Our ref: 12578580

IERRT ISH2 Hearing – Response to Action Item 15

Figure 1 Off-site Freight Facilities

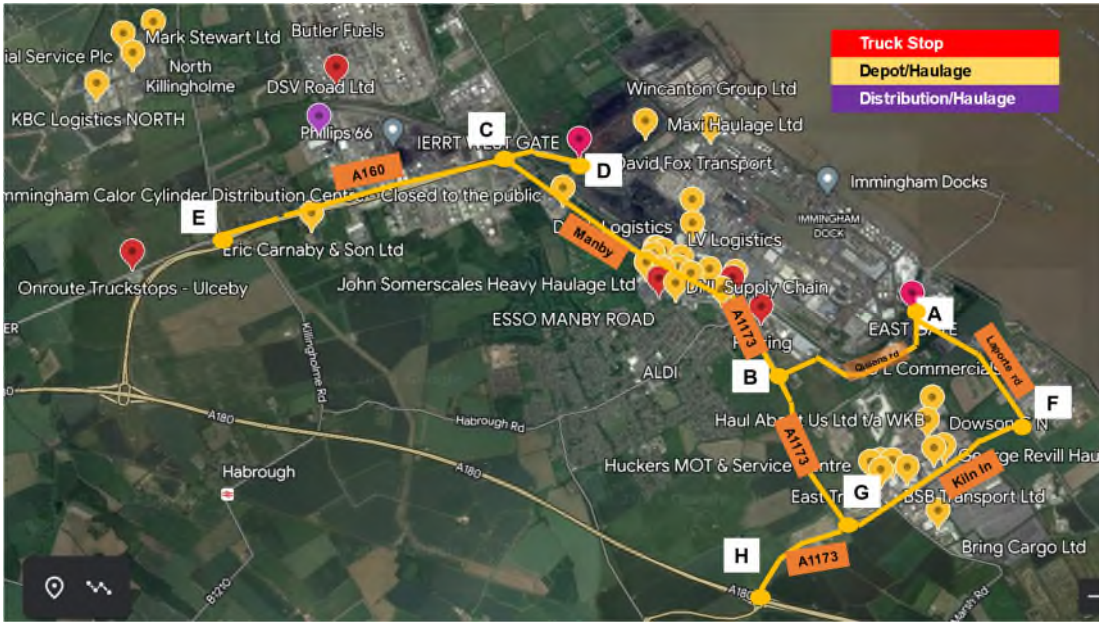
In addition to the considered sites, there are a number of other major depots, truck stops, refuelling stations and driver amenities located across the Immingham region, as shown in Figure 1.

There are several major facilities on the A160, including DSV road limited depot and distribution centre, and DFDS Logistics depot and distribution centre. These two sites represent a large percentage of offsite capacity and are major contributors to trip generations. Due to their depot functions, a number of drivers will park their truck heads at these facilities before returning home via using their private vehicles. These drivers would then return at the start of the next shift to acquire the truck head, transfer to the port to acquire their first trailer and begin that shift operations. This type of behaviour can be seen in the heatmap presented in Figure 2, which show that the majority of the drivers arriving at the Port of Immingham in the morning begin from a distance of less than 50 km away.

The presence of these facilities and the associated driver behaviours does not appear to be considered within the distribution assessment.

- Complete the review of data provided by interested parties and provide commentary;
- Undertake an assessment of all freight facilities within the region rather than just a selection, with consideration of potential trip generation or termination;
